RE-ALIGNMENT MODEL 2
FOR SIERRA HACIENDA HOMES
DBA TRB HOLDINGS, 1/29/21

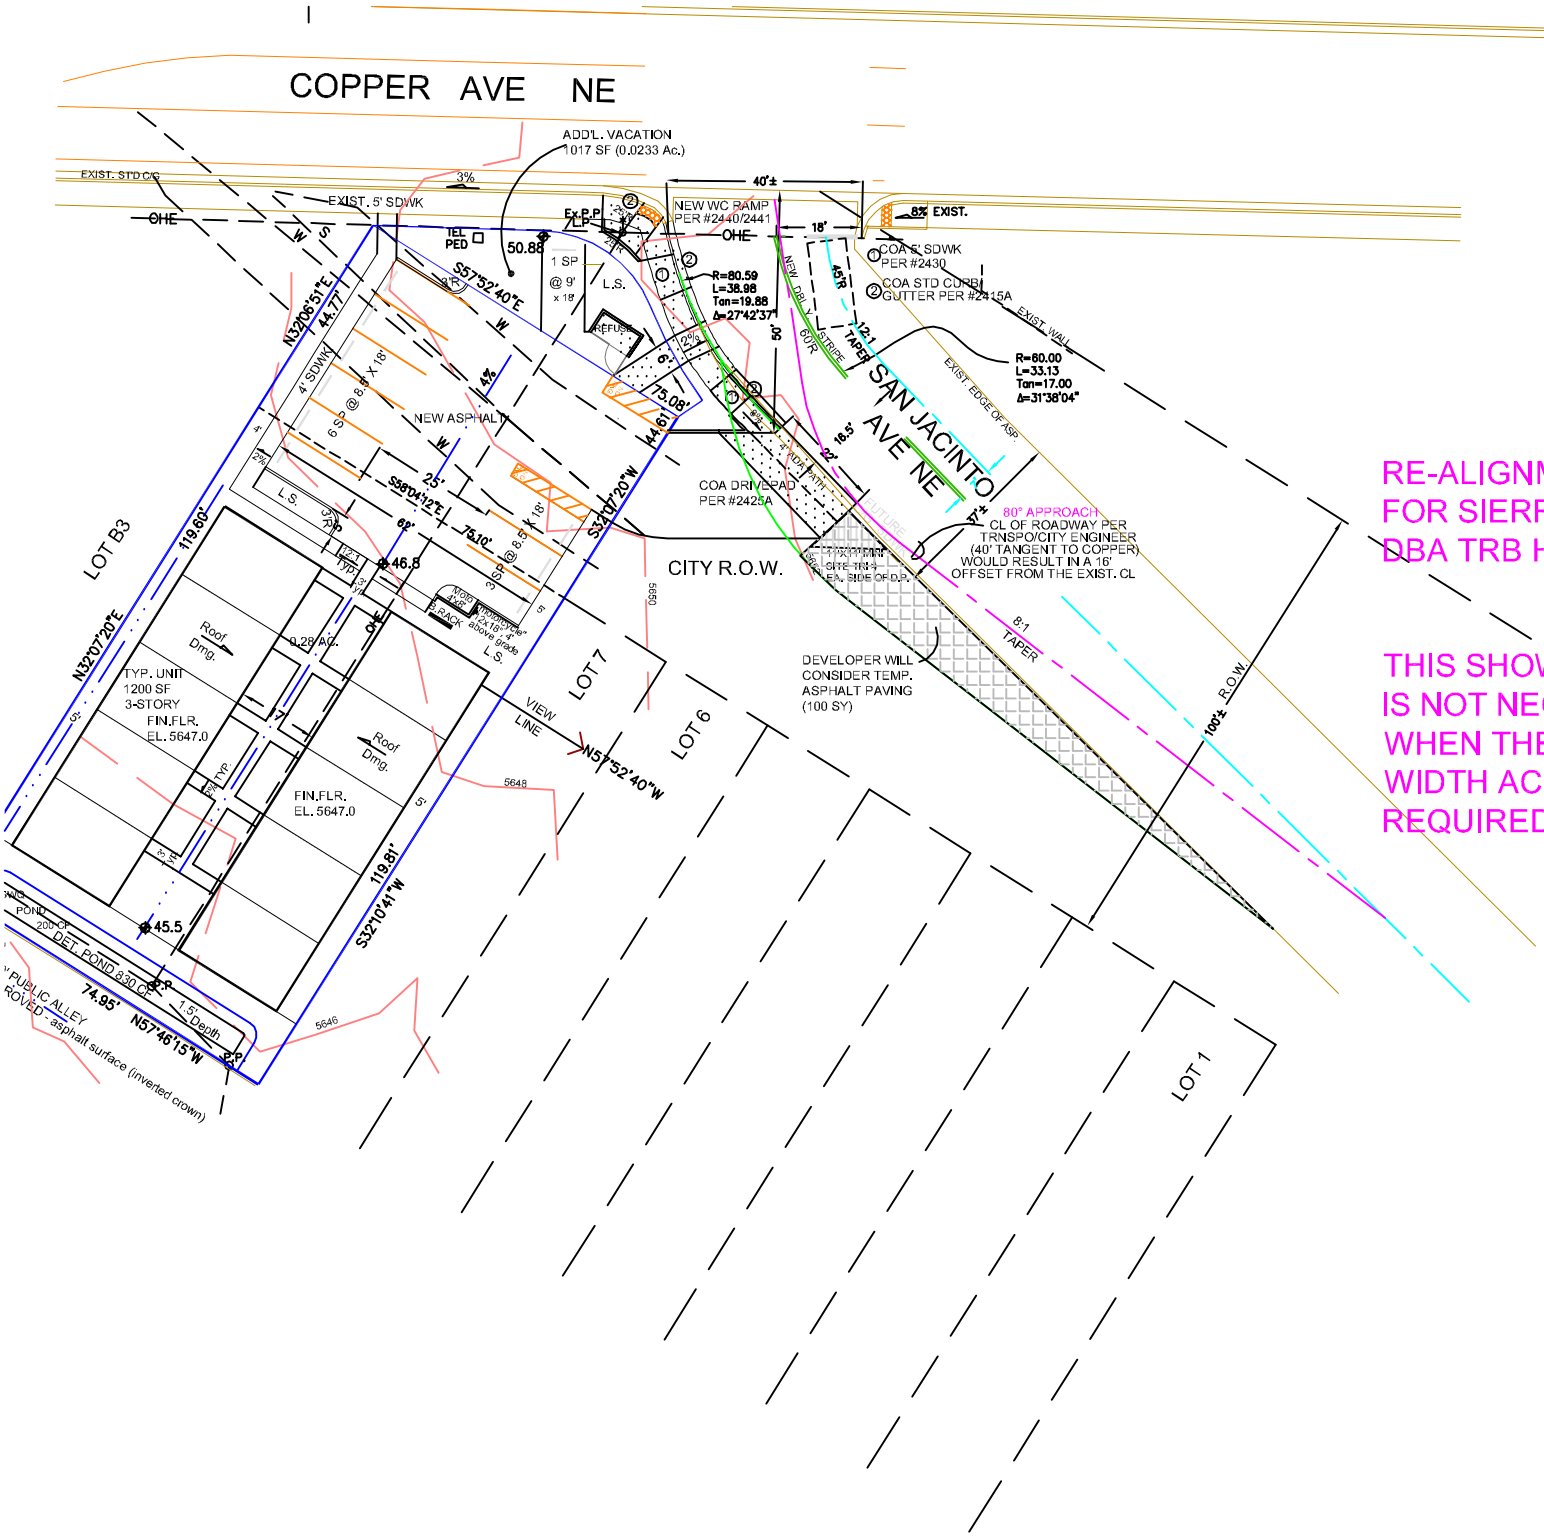
THIS SHOWS THAT RE-ALIGNMENT
IS NOT NECESSARY. WHY RE-ALIGN
WHEN THE EXISTING ROADWAY
WIDTH ACCOMODATES THE DPM
REQUIRED HORIZ. GEOMETRY PROVISIONS
